Table of Contents for Governmental Agency Comments and Responses

**COMMENTS FOR THE DRAFT SUPPLEMENTAL ENVIRONMENTAL IMPACT REPORT
(DEIR) FOR THE EXXONMOBIL INTERIM TRUCKING FOR SANTA YNEZ UNIT (SYU)
PHASED RESTART PROJECT**

ExxonMobil Interim Trucking Project
Governmental Agency Comments and Responses

July 2020
OurAirSBC
Final SEIR

EA 05-1C950, Santa Barbara County, US 101, Post Mile R36.0 to R37.0

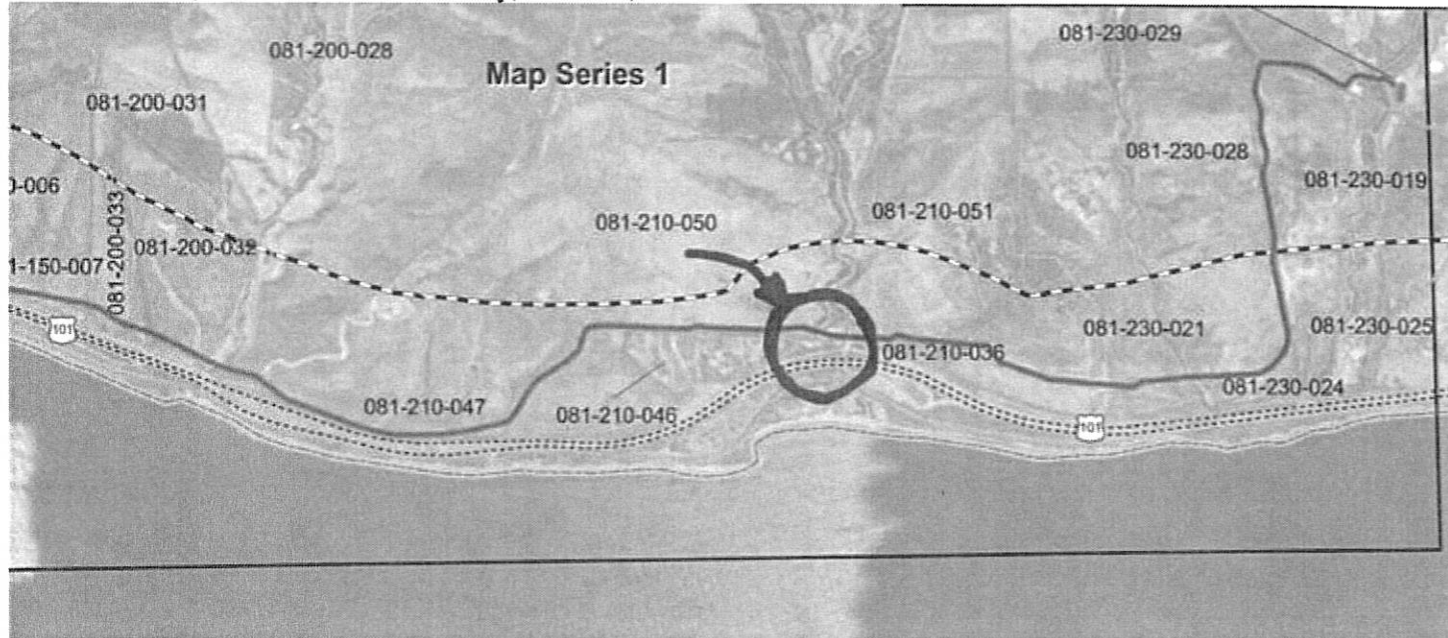
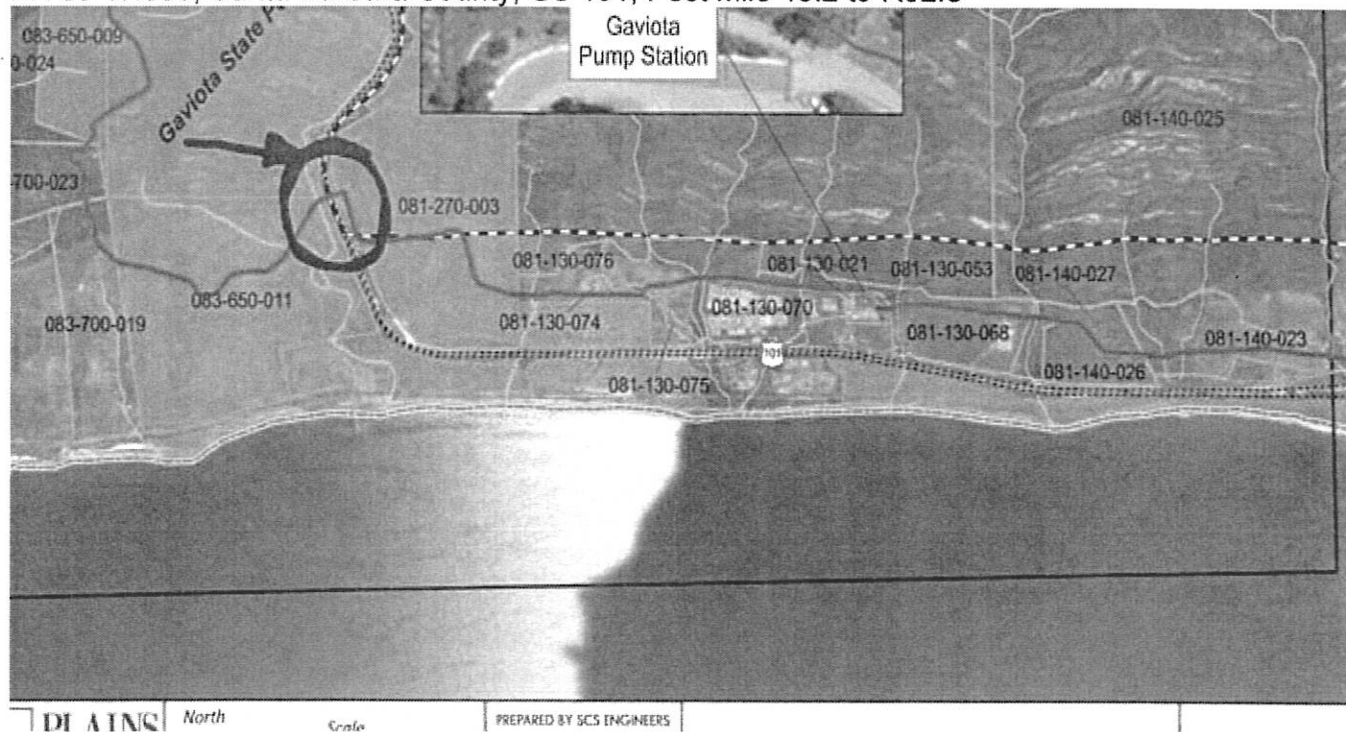
The Design Branch of Caltrans District 5 currently has two project that may be affected by the Plains Replacement Pipeline Project, and more specifically, Line 901R. Both projects are in the Project Approval & Environmental Document (PA&ED) phase. See attached map for locations of these projects.

The first project ID# EA 05-1C950, Santa Barbara County, US 101, Post Mile R36.0 to R37.0, is the replacement of the Refugio Bridges on US 101 near the Refugio Beach State Park, the replacement of the bridge rails on the north bound on-ramp, and improve fish passage along Canada Del Refugio Creek. It appears that the pipeline 901R will cross a Caltrans drainage easement area at the fish passage improvement project area. Excavation work within the channel can be expected to be up to ten feet deep below the existing flow line. Plains Replacement Pipeline Project will need to coordinate with the Caltrans to ensure the new 901R pipeline will be sufficiently deep enough that it will not be impacted by our construction and that their facility can be protected in place.

The second project ID# EA 05-1H860, Santa Barbara County, US 101, Post Mile 46.2 to 52.3, is to rehabilitate the roadway. It appears that the pipeline 901R will cross the highway just south of the Gaviota Roadside Rest Stop. A transverse crossing of this nature will require an encroachment permit. Through the Caltrans design process, we will most likely be requesting pot-holing of any existing facility to insure it meets our minimum depth requirements and that Caltrans will not have any conflicts. Plains Replacement Pipeline Project will need to coordinate with Caltrans to make sure the new pipeline 901R will be sufficiently deep enough to ensure that it will not be impacted by any Caltrans construction and that it will meet Caltrans minimum depth requirements.

CLTR-21	This comment is regarding the Plains Replacement Pipeline Project and does not apply to the ExxonMobil Interim Trucking Project., since The Project would not involve the installation of pipelines in the Caltrans right-of-way.
CLTR-22	This comment is regarding the Plains Replacement Pipeline Project and does not apply to the ExxonMobil Interim Trucking Project since the Project would not involve the installation of pipelines in the Caltrans right-of-way.
CLTR-23	This comment requests a copy of the Traffic Impact Analysis (TIA) for the Plains Pipeline Replacement Pipeline Project, which is unrelated to the ExxonMobil Interim Trucking Project. See associated responses to CLTR-6 and CLTR-16.
CLTR-24	This comment is regarding the Plains Replacement Pipeline Project and does not apply to the ExxonMobil Interim Trucking Project. The proposed , since the Project would not involve the installation of pipelines in the Caltrans right-of-way.
